ADMINISTRATIVE SHORT PLAT REPORT & DECISION

REPORT DATE:	May 11, 2015
Project Name:	Central Island Short Plat
Project Number:	LUA14-001482, SHPL-A
Project Manager:	Clark H. Close, Associate Planner
Owner/Applicant:	Thuong Pham & Niem Thi Nguyen, 3556 120th Ave SE, Bellevue, WA 98006
Project Location:	3413 NE 7th Street, Renton, WA 98056 (APN 801110-0110)
Project Summary:	The applicant is requesting approval of a 3-lot short plat totaling 28,670 square feet (0.66 acres) for the future development of two (2) new single-family houses. The subject property is located on the south side of NE 7th St, east of Newport Ct E, within the Residential Eight (R-8) zoning district. The proposed lots range in size from 7,088 sf to 8,920 sf. The residential density is 5.5 dwelling units per net acre. Access to proposed lots would be from NE 7th Street utilizing a shared driveway tract (Tract A). Half street frontage improvements will be completed along NE 7th Street. No sensitive areas or special features are located on the proposed project site which slopes to the southwest. Three significant trees onsite will be replaced with 6 new trees. The existing house on Lot 1 will be retained as part of t

10-28-14
3413 NE 7TH SHORT PLAT
LANDSCAPE PLAN
SHEET 1 OF 1

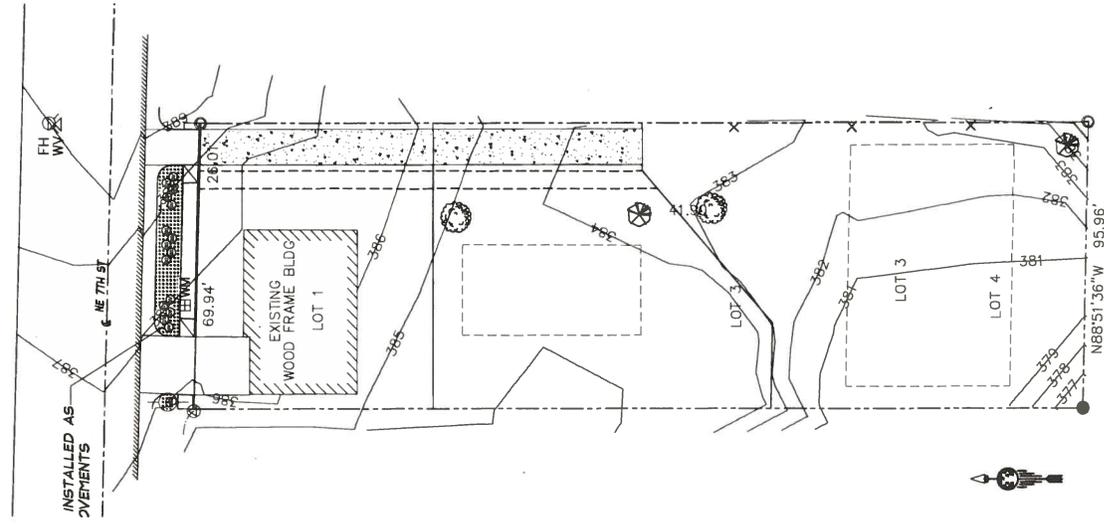
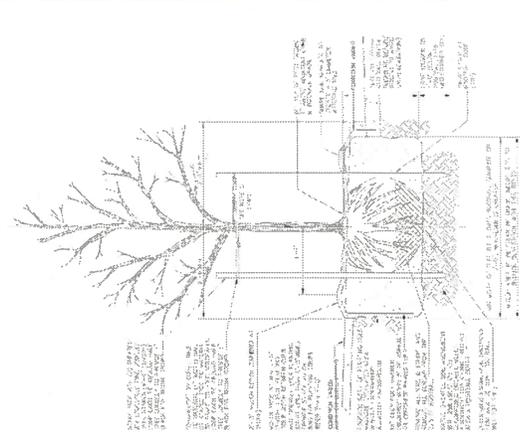
1. The applicant shall revise the landscaping plan to include a minimum of two (2) trees within the front yards of Lots 2 and 3. A revised landscaping plan shall be submitted to, and approved by, the Current Planning Project Manager prior to construction permit issuance.

2. The applicant shall plant screening shrubs and groundcover within the sliver of land created between the 20-foot wide shared driveway and the east property line at the northeast corner of the property. A revised landscaping plan shall be submitted to, and approved by, the Current Planning Project Manager prior to construction permit issuance.

4. The applicant shall plant two (2) public street trees within the 8-foot planter strip on NE 7th Street. The final detailed landscape plan must be reflective of the proposed lot lines identified in the site plan and shall be prepared by a landscape architect registered in the State of Washington.
